**DSP-18039**  
**DDS-651**

STAFF REPORT

SUBJECT: Detailed Site Plan DSP-18039  
Departure from Design Standards DDS-651  
Type 2 Tree Conservation Plan TCP2-003-2019  
Townes at Peerless

# SIGNAGE

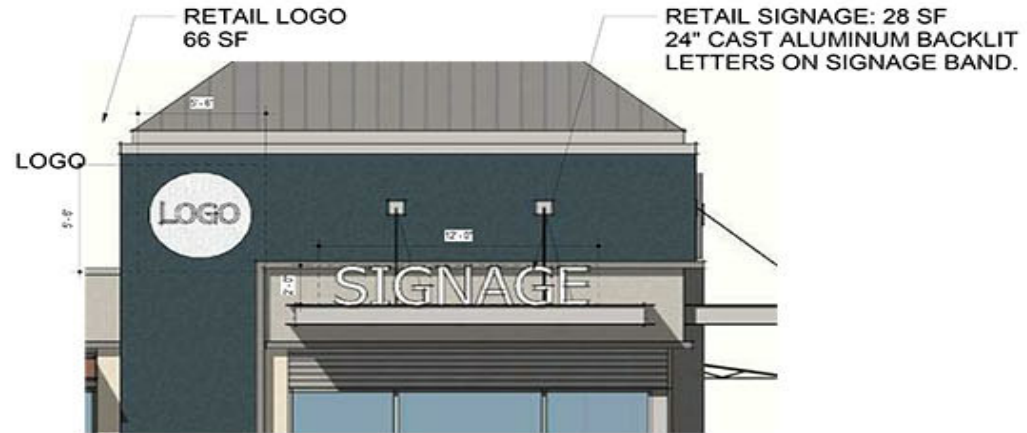
- a. Revise the primary identification sign to include a brick base to match that of the building and move it out of the public utility easement.
- b. Provide physical elements, such as fencing or landscaping, to more clearly define a separation between the residential and commercial portions of the development, and incorporate the wayfinding sign into this design, where appropriate, to be reviewed and approved by the Urban Design Section as designee of the Prince George’s County Planning Board.
